53132A-07A

S E R V I C E N O T E

53132A 225 MHz Counter

Serial Numbers: MY47000000 to MY47001807
SG47000000 to SG47000268

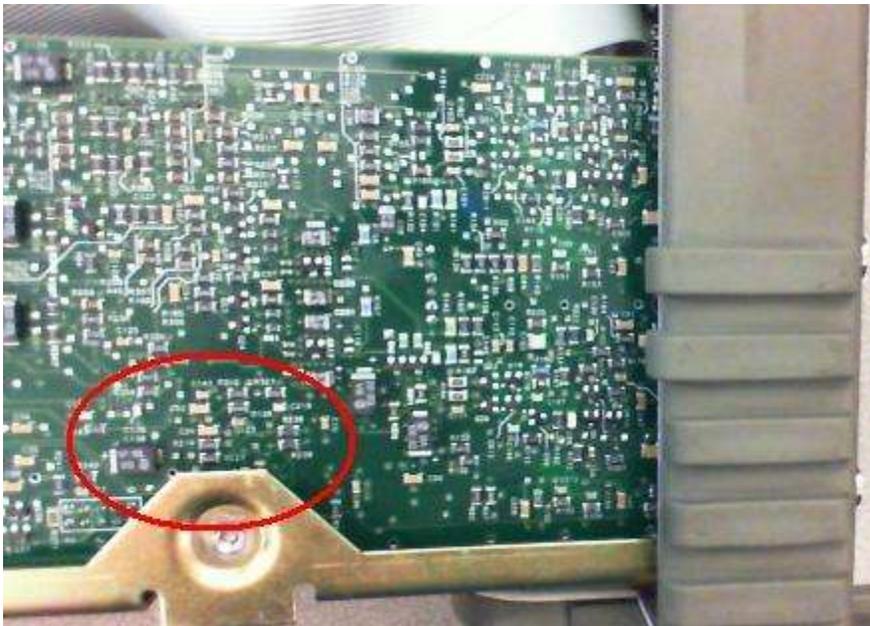
Measurements on counters with A1 motherboard (53131-68024 or 53132-68024) may have intermittent readings that are significantly outside the specified accuracy under the following conditions:

- Channel 1 is configured to use Auto Trigger Level,
- AND**
- Channel 2 either:
 - has been used to make a measurement since the last power cycle, or
 - has been used to make pulse width, time interval or rise/fall time measurements (including Channel 1 measurements with Common 1: ON), or
 - has an input signal with an amplitude >10 Vpp

Replace resistor 0699-1318 at reference designators R219 and R218 with 0699-1377 (2.37 KOhm).
